**From:** cindy bloom <cbloom571@gmail.com>  
**Sent:** Tuesday, April 17, 2018 8:13 AM  
**To:** Richard, Dan@HSR; Boehm, Michelle@HSR; Kelly, Brian@HSR; HSR Draft Business Plan 2018; HSR Southern California@HSR; HSR boardmembers@HSR; Arellano, Genoveva@HSR  
**Cc:** cindy bloom; Dave DePinto  
**Subject:** Video from United Southern California Communities as Official Comment to 2018 Business Plan

**Comments for the Record, California High-Speed Rail  
Board meeting – to be included into the official  
minutes of this session in Los Angeles on  
April 17, 2018, Los Angeles**

Re: *Comments on DRAFT CHSRA 2018 Business Plan*

**Subject:** REQUEST FOR IMMEDIATE STOP WORK ORDER FOR MERCED TO FRESNO SECTION  
**Attachments:** Attach 1 CHSRA Merced to Fresno Section.pdf; Attach 2 HSR Structure over UPRR.pdf; Attach 3 Structure over UPRR.pdf; Attach 4 Aerial Structure.pdf; Attach 5 Aerial Deck.pdf; Attach 6 Horizontal Curve.pdf; Attach 7 Vertical Curve.pdf; Attach 8 Superelevation.pdf; Attach 9 Curve on bridge deck.pdf; Attach 10 HSR Curve Criteria.pdf; Attach 11 Temp Extremes Fresno 1.pdf; Add Attach Curve Criteria Highway.pdf; Stop Work Order.pdf; Article HSR Derailment.pdf; Request

ATTACHMENT 2

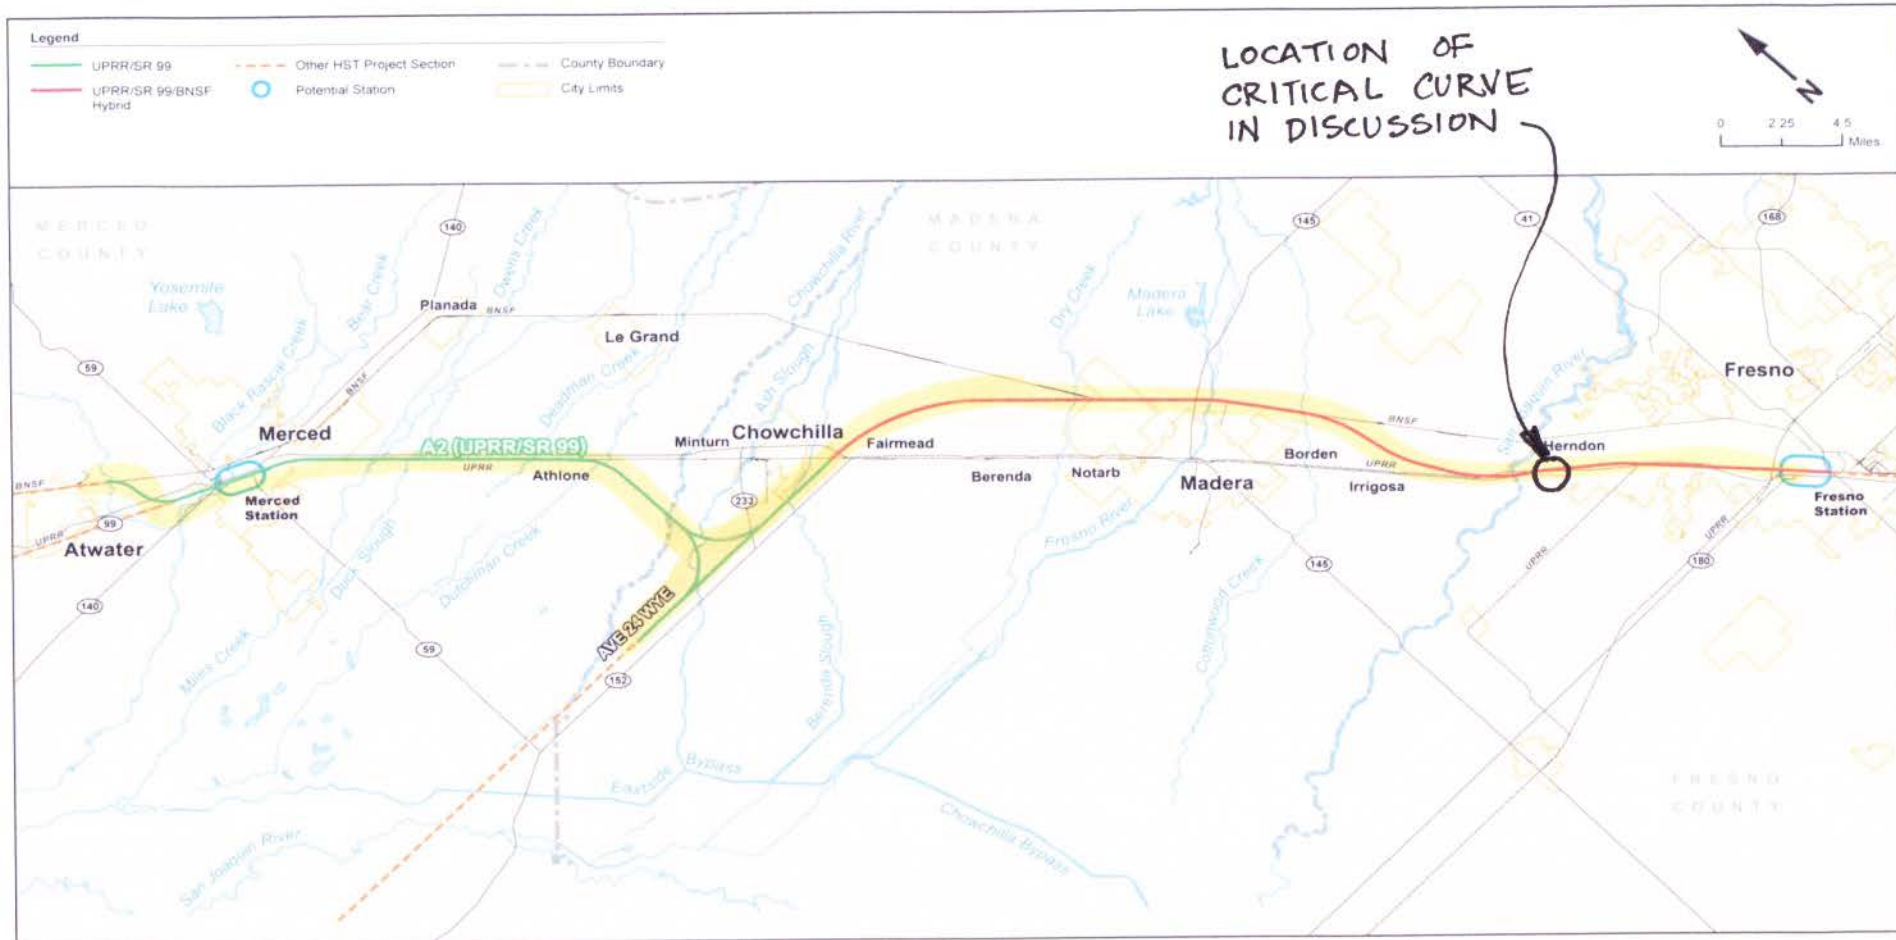
HSR STRUCTURE OVER UPRR TRACKS NEAR HERNDON DRIVE, FRESNO  
LOOKING NORTHWEST

CHANGE IN TRACK STRUCTURE

ATTACHMENT 4  
HSR STRUCTURE NEAR  
SAN JOAQUIN RIVER,  
TRACK TO BE BUILT  
ON TOP OF ELEVATED  
STRUCTURE

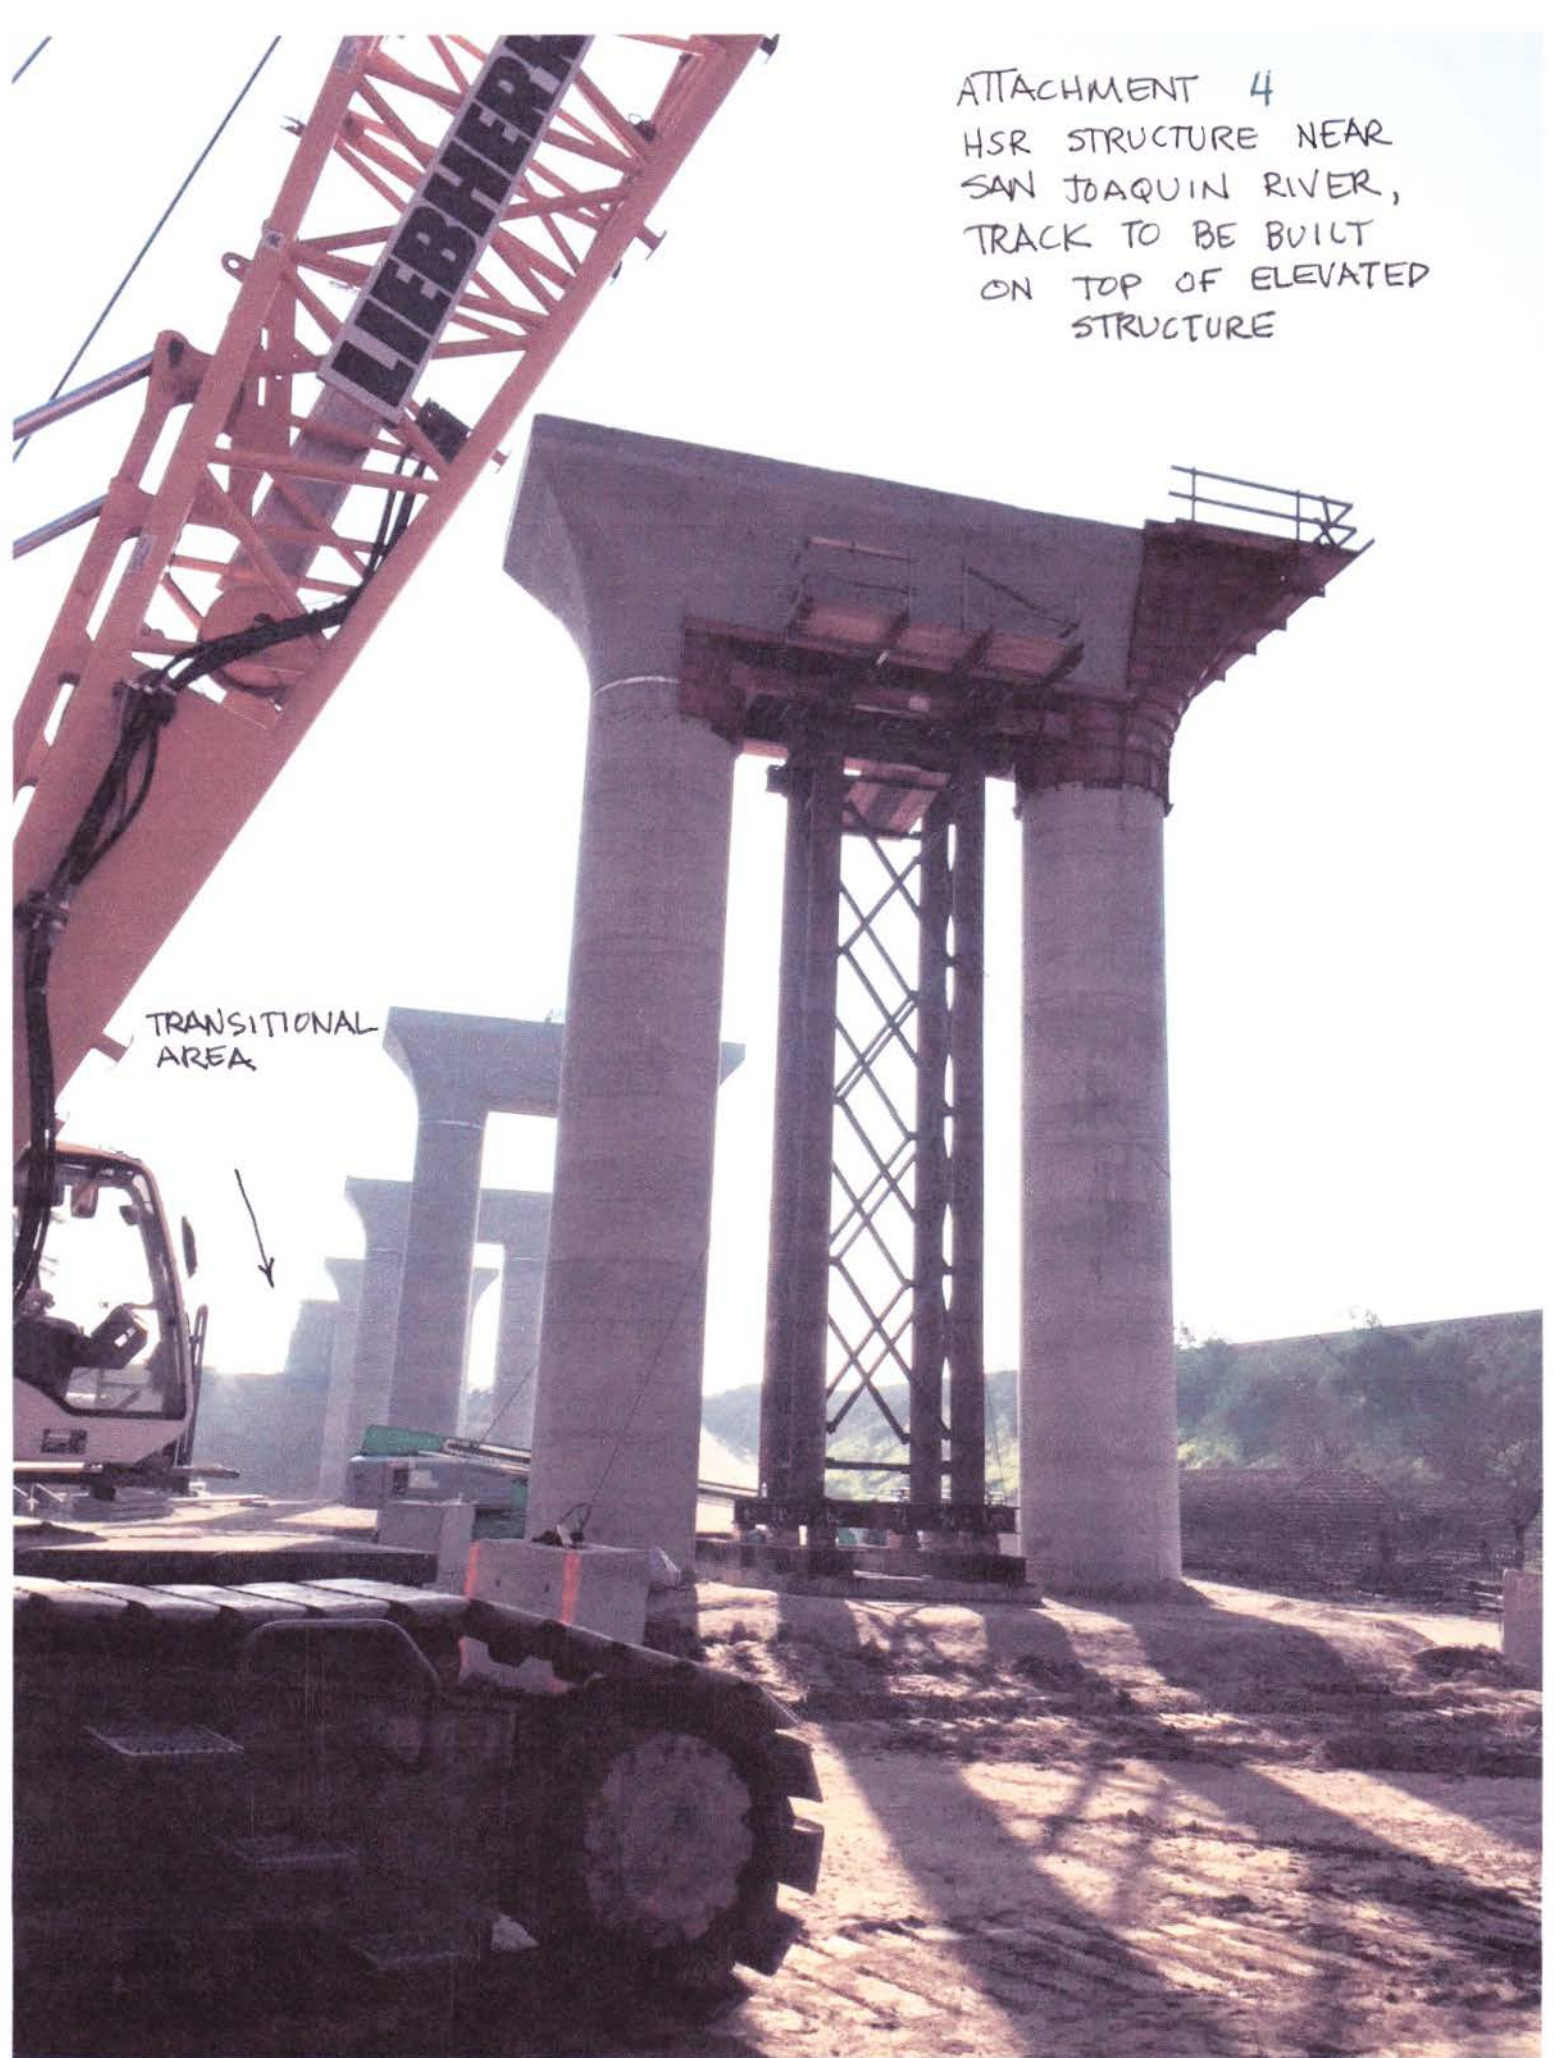
# CHANGE IN TRACK STRUCTURE

## ATTACHMENT 5

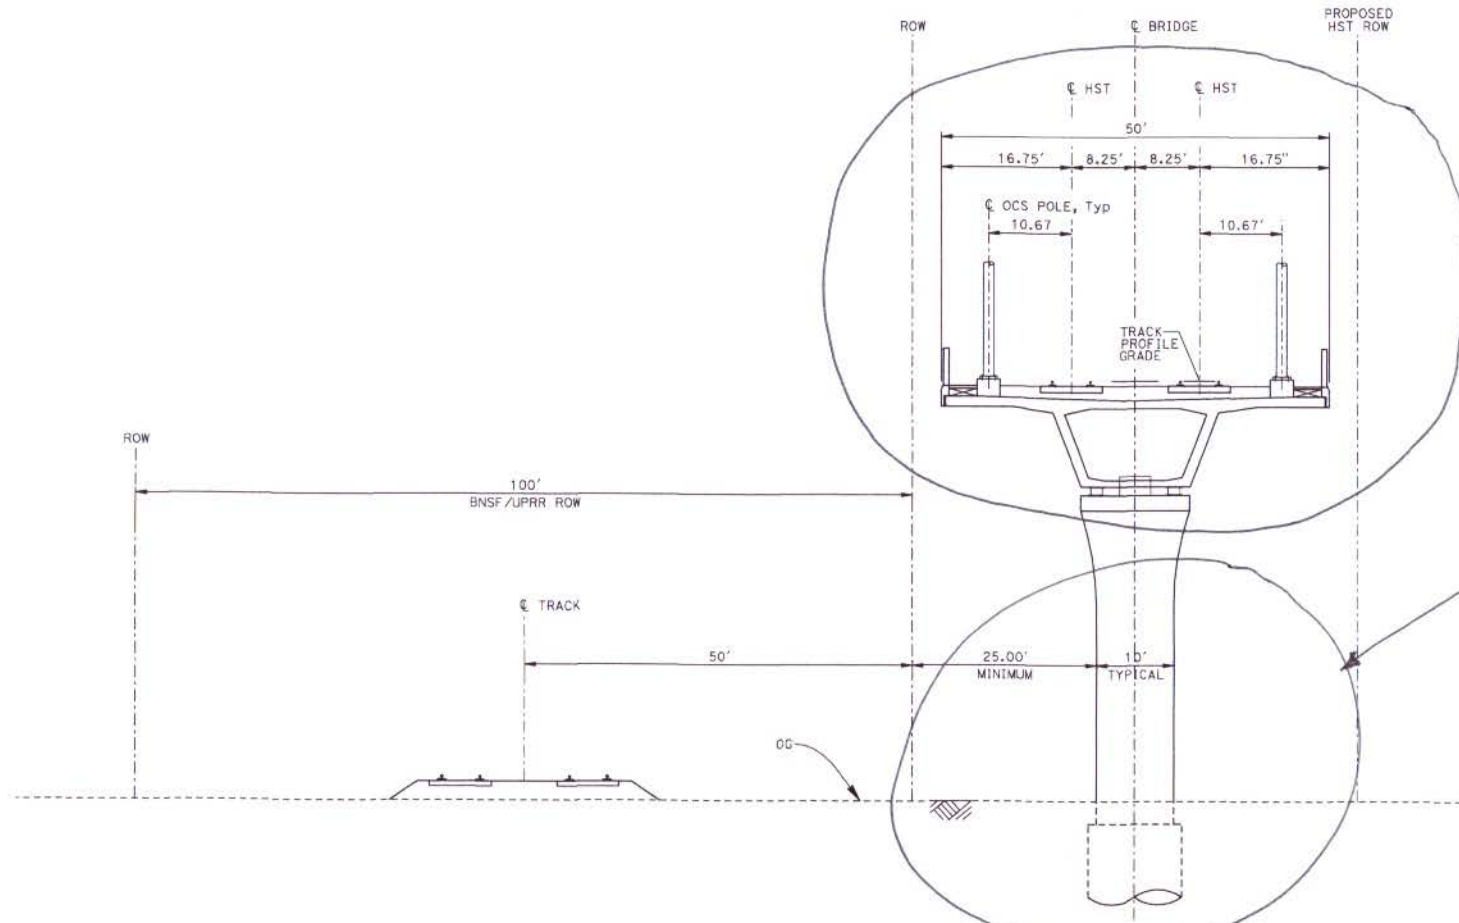
THE AERIAL DECK WILL NEED TO BE RE-DESIGNED TO ACCOMODATE ACCEPTABLE CURVATURE

**CALIFORNIA HIGH-SPEED TRAIN PROJECT**  
**MERCED TO FRESNO**  
 HYBRID  
 PLAN AND PROFILE  
 STA 2690+00 TO STA 2740+55.75

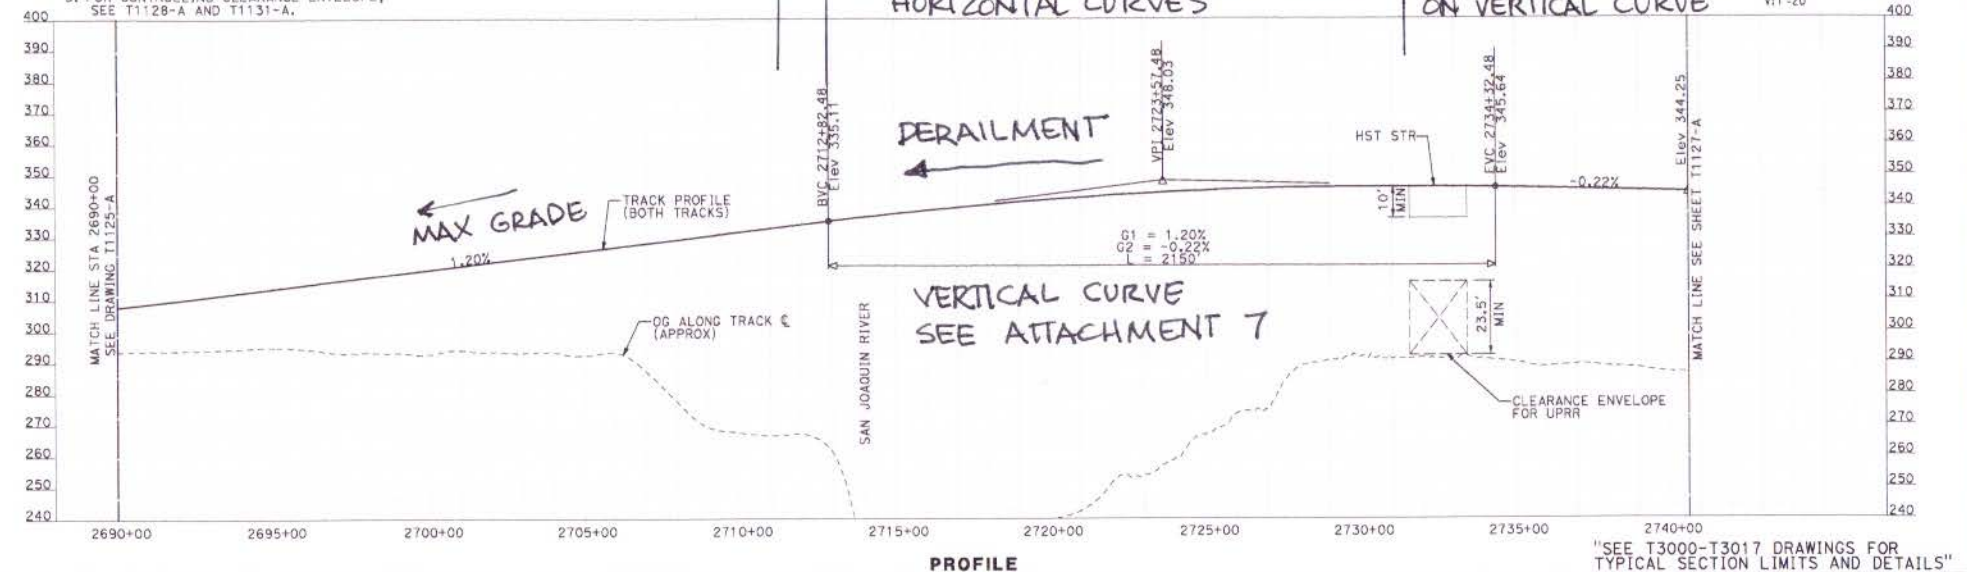
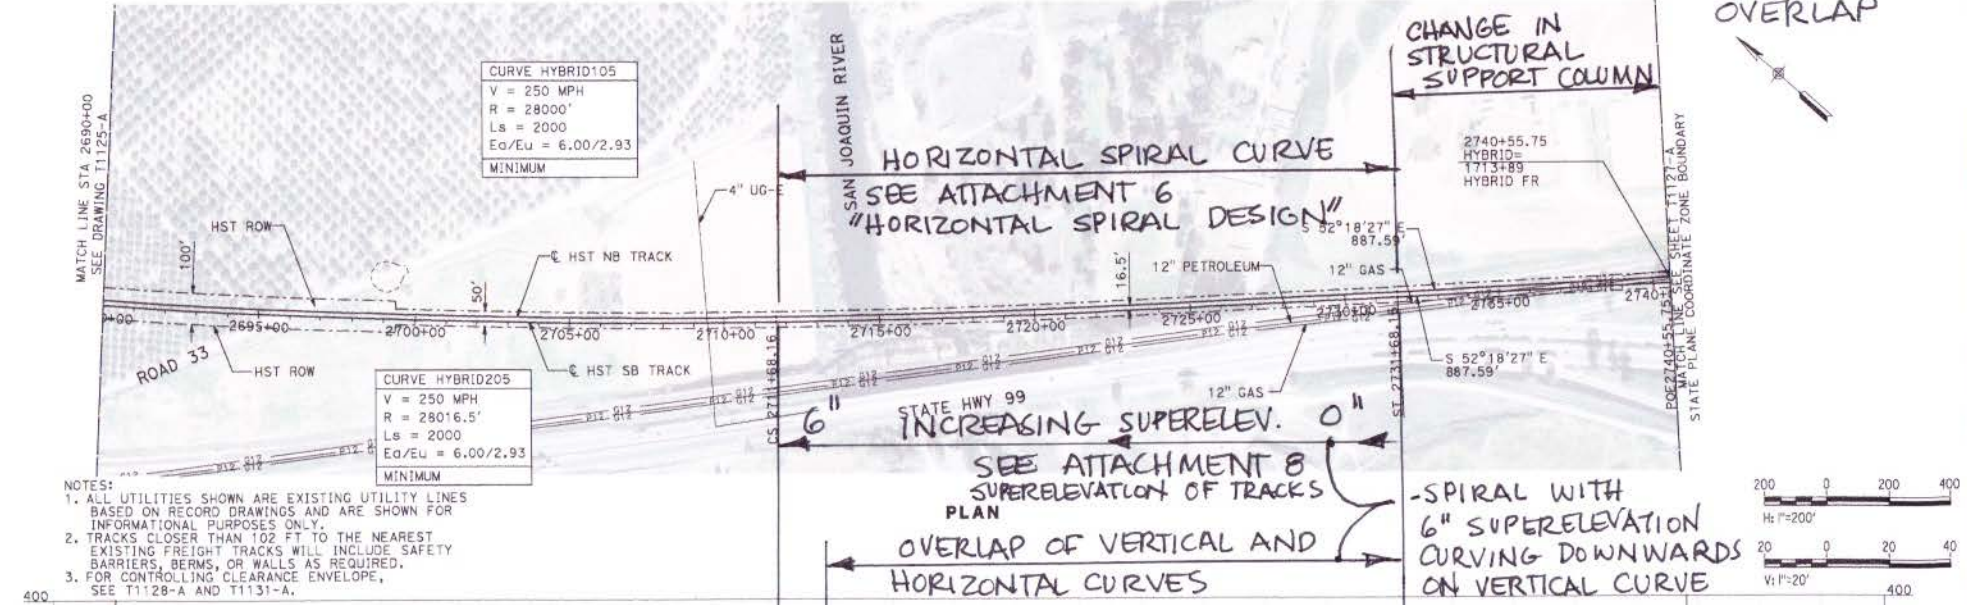
CHANGE IN STRUCTURAL SUPPORT COLUMN
